PRODUCT CHANGE NOTIFICATION (PCN)

AB973 DSUB CABLE

CHANGE NOTIFICATION: PCN 20221216_AB973

DESCRIPTION OF CHANGES: CHANGE OF DATA SHEET
CHANGE OF PRODUCT DESIGN
New Draw.-No. ASS_7065_CAreV02

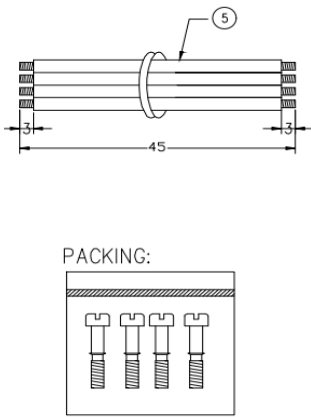
AB973	OLD VERSION	AB973	NEW VERSION																																										
<p>Dimension</p>		<p>Dimension</p>																																											
BOM		BOM																																											
<table border="1"> <thead> <tr> <th>No.</th> <th>DESCRIPTION</th> <th>Q'TY</th> </tr> </thead> <tbody> <tr> <td>5</td> <td>UL1007 26AWG INSULATOR WIRE, LENGH</td> <td>25</td> </tr> <tr> <td>4</td> <td>PCB: SAK-7 ELECTRO-PLATED HOOD</td> <td>1 1SET</td> </tr> <tr> <td>3</td> <td>SCREW 4*12.5mm, #4-40,WITH PAD,ASSEMBLY TYPE</td> <td>4</td> </tr> <tr> <td>2</td> <td>DB25 MALE, GOLD FLASH ON CONTACTS, BLUE INSULATOR</td> <td>1</td> </tr> <tr> <td>1</td> <td>DB25 MALE, GOLD FLASH ON CONTACTS, BLUE INSULATOR</td> <td>1</td> </tr> </tbody> </table>		No.	DESCRIPTION	Q'TY	5	UL1007 26AWG INSULATOR WIRE, LENGH	25	4	PCB: SAK-7 ELECTRO-PLATED HOOD	1 1SET	3	SCREW 4*12.5mm, #4-40,WITH PAD,ASSEMBLY TYPE	4	2	DB25 MALE, GOLD FLASH ON CONTACTS, BLUE INSULATOR	1	1	DB25 MALE, GOLD FLASH ON CONTACTS, BLUE INSULATOR	1	<table border="1"> <thead> <tr> <th>NO.</th> <th>DESCRIPTION</th> <th>QTY</th> <th>UNIT</th> </tr> </thead> <tbody> <tr> <td>5</td> <td>UL1061 26AWG INSULATOR WIRE,</td> <td>25MIN</td> <td>PCS</td> </tr> <tr> <td>4</td> <td>PCB PVC HOOD</td> <td>1 1</td> <td>PCS SET</td> </tr> <tr> <td>3</td> <td>SCREW ,2.4*11.9mm, #4-40,WITH PAD,ASSEMBLY TYPE</td> <td>4</td> <td>PCS</td> </tr> <tr> <td>2</td> <td>DB25 MALE, GOLD FLASH ON CONTACTS, WHITE INSULATOR</td> <td>1</td> <td>PCS</td> </tr> <tr> <td>1</td> <td>DB25 MALE, GOLD FLASH ON CONTACTS, WHITE INSULATOR</td> <td>1</td> <td>PCS</td> </tr> </tbody> </table>		NO.	DESCRIPTION	QTY	UNIT	5	UL1061 26AWG INSULATOR WIRE,	25MIN	PCS	4	PCB PVC HOOD	1 1	PCS SET	3	SCREW ,2.4*11.9mm, #4-40,WITH PAD,ASSEMBLY TYPE	4	PCS	2	DB25 MALE, GOLD FLASH ON CONTACTS, WHITE INSULATOR	1	PCS	1	DB25 MALE, GOLD FLASH ON CONTACTS, WHITE INSULATOR	1	PCS

No.	DESCRIPTION	Q'TY																																											
5	UL1007 26AWG INSULATOR WIRE, LENGH	25																																											
4	PCB: SAK-7 ELECTRO-PLATED HOOD	1 1SET																																											
3	SCREW 4*12.5mm, #4-40,WITH PAD,ASSEMBLY TYPE	4																																											
2	DB25 MALE, GOLD FLASH ON CONTACTS, BLUE INSULATOR	1																																											
1	DB25 MALE, GOLD FLASH ON CONTACTS, BLUE INSULATOR	1																																											
NO.	DESCRIPTION	QTY	UNIT																																										
5	UL1061 26AWG INSULATOR WIRE,	25MIN	PCS																																										
4	PCB PVC HOOD	1 1	PCS SET																																										
3	SCREW ,2.4*11.9mm, #4-40,WITH PAD,ASSEMBLY TYPE	4	PCS																																										
2	DB25 MALE, GOLD FLASH ON CONTACTS, WHITE INSULATOR	1	PCS

1	DB25 MALE, GOLD FLASH ON CONTACTS, WHITE INSULATOR	1	PCS																																										
FOR DETAIL, PLEASE TAKE ATTACHED NEW DRAWING: FOR REFERENCE

AB973 OLD VERSION	AB973 NEW VERSION
<p>PACKING</p> 	<p>PACKING</p> <p>Components inside the PE bag:</p> 
<p>FOR DETAIL, PLEASE TAKE ATTACHED NEW DRAWING: FOR REFERENCE</p>

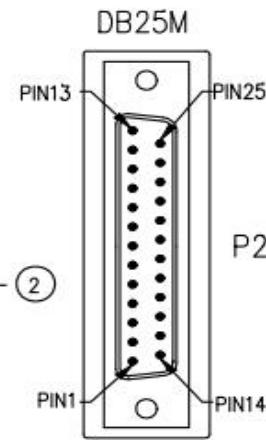
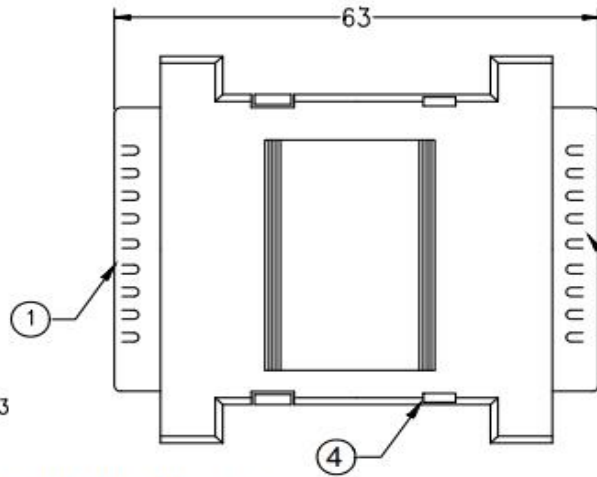
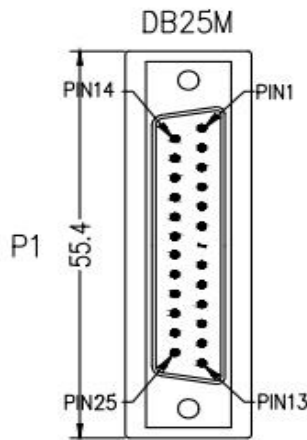
③ Components inside the PE bag:

NO.	DESCRIPTION	QTY	UNIT
⑤	UL1061 26AWG INSULATOR WIRE,	25MIN	PCS
④	PCB PVC HOOD	1	PCS SET
③	SCREW 2.4*11.9mm, #4-40, WITH PAD, ASSEMBLY TYPE	4	PCS
②	DB25 MALE, GOLD FLASH ON CONTACTS, WHITE INSULATOR	1	PCS
①	DB25 MALE, GOLD FLASH ON CONTACTS, WHITE INSULATOR	1	PCS

Scale	FREE					Date	Name	Customer-No.
TOLERANCE						Drawn	11.02.2014	Ray
X.	±1.0					Approved	16.12.2022	Daniel
X.X	±0.3							
		③	Update dimension and packing	16.12.2022	Daniel			
DIM	TOL	①	Update	14.05.2020	Winnie			
Angle	±0.5	②	Drawn	11.02.2014	Ray			
		Id.	Modification	Date	Name
